Converting from CY14B101K/STK17TA8 to CY14B101KA

AN55658

This application note provides information on converting from CY14B101K/STK17TA8 parts to the CY14B101KA. It lists the parameter differences between the parts and the design considerations when converting existing applications from CY14B101K/STK17TA8 to CY14B101KA.

Figure 1. RTC Recommended Component Configuration

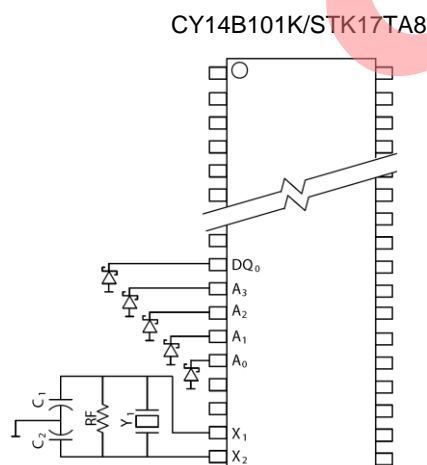
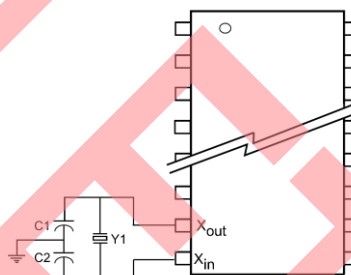
The RTC oscillator has been improved in CY14B101KA to ensure that the oscillator stability is immune to the ground currents in the substrate caused by signal undershoots. Hence, as shown in [Figure 1](#) on page 3, the Schottky diodes recommended in CY14B101K/STK17TA8 are not required in CY14B101KA applications (refer to the application note [AN49947](#), Undershoot Effect in RTC Circuit of 0.25 μ nvSRAM). The values of C1, C2, are different and RF is not required in CY14B101KA. The RTC oscillator provides excellent stability with the standard best practices usually required for RTC oscillators.

The RTC oscillator circuit has been greatly improved in CY14B101KA to make the oscillator immune to signal undershoots. This is a major improvement from the CY14B101K/STK17TA8 which required external Schottky diodes to keep the input signals free of undershoots greater than 0.5 V. The C1, C2 values are different in the CY14B101KA. The I_{BAK} current is higher in the CY14B101KA but the RTC circuit provides the same backup times with external V_{RTCcap} as in CY14B101K/STK17TA8, namely, 72 hours with $V_{RTCcap} = 0.1$ F, 14 days with 0.47 F, and 30 days with 1 F.

Y1 = 32.768 kHz

RF = 10M Ohm

C1 = 0 (install cap footprint, but leave unloaded)

C2 = 56 pF + 10% (do not vary from this value)

Y1 = 32.768 kHz (12.5 pF)

C1 = 10 pF

C2 = 67 pF

Figure 2. CY14B101K/STK17TA8: AC Parameters Related to $\overline{\text{HSB}}$

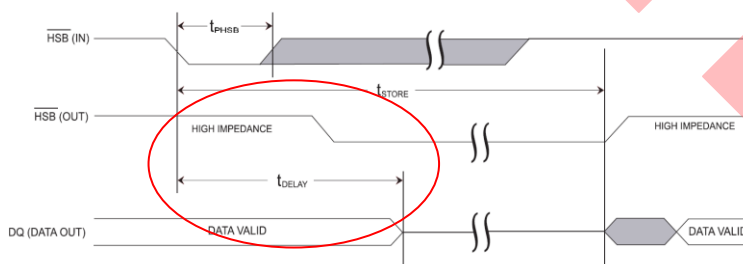
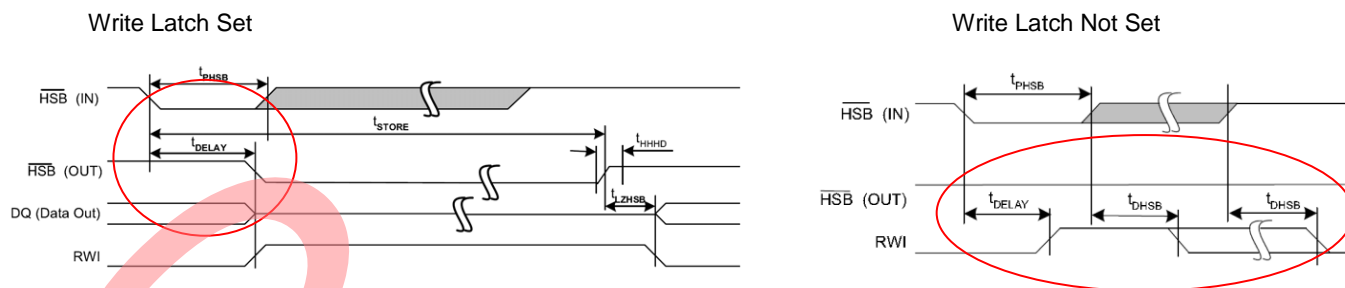
If a write latch is set and the $\overline{\text{HSB}}$ pin is pulled low, CY14B101K/STK17TA8 enables 1 us to 70 us time for write operations to complete before STORE operation begins and

reads and writes are inhibited. This potentially enables inadvertent data to be written to the nvSRAM during the t_{DELAY} duration.

In CY14B101KA, the t_{DELAY} parameter enables only one write cycle time for any ongoing write to complete after $\overline{\text{HSB}}$ pin is pulled low. This improvement provides better security from inadvertent write operations.

Also, if $\overline{\text{HSB}}$ pin is pulled low externally for a minimum of t_{PHSB} time on CY14B101KA, the output driver of $\overline{\text{HSB}}$ pin pulls the pin low only indicating a STORE operation within 25 ns (t_{DELAY}). This parameter for $\overline{\text{HSB}}$ low to STORE busy is not specified in the CY14B101K/STK17TA8. (See Figure 2 and Figure 3)

If no writes are performed since the last STORE/RECALL operation, STORE operation does not start when $\overline{\text{HSB}}$ is pulled low. However, the $\overline{\text{HSB}}$ pin is still internally pulled low for 1 us to 70 us (t_{DELAY}) time in the CY14B101K/STK17TA8 device.

CY14B101KA device does not pull the $\overline{\text{HSB}}$ pin low internally if write latch is not set. This improvement prevents the possibility of being in an infinite loop when $\overline{\text{HSB}}$ pins of two nvSRAM devices are ganged.

Figure 4. CY14B101K/STK17TA8: Power-Up Recall

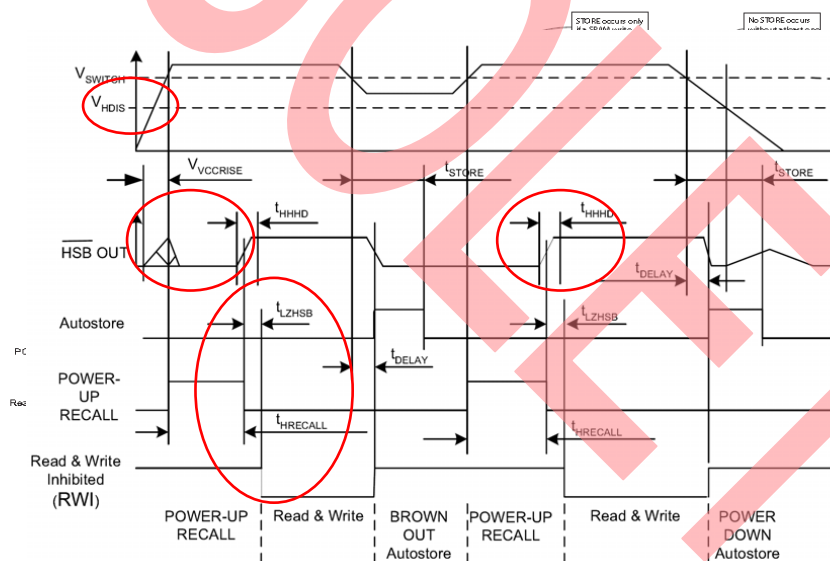
Additional parameters are specified in CY14B101KA such as $\overline{\text{HSB}}$ Output Disable Voltage (V_{HDIS}), $\overline{\text{HSB}}$ To Output Active Time (t_{LZHSB}), and $\overline{\text{HSB}}$ High Active Time (t_{HHHD}) which helps in system design. Refer to Figure 4 and Figure 5 for the definition of the additional specs in power-up. Also, note that $\overline{\text{HSB}}$ remains low until the end of the power-up in the new part. This guards against the system inadvertently thinking the part has completed the boot up prior to real completion.
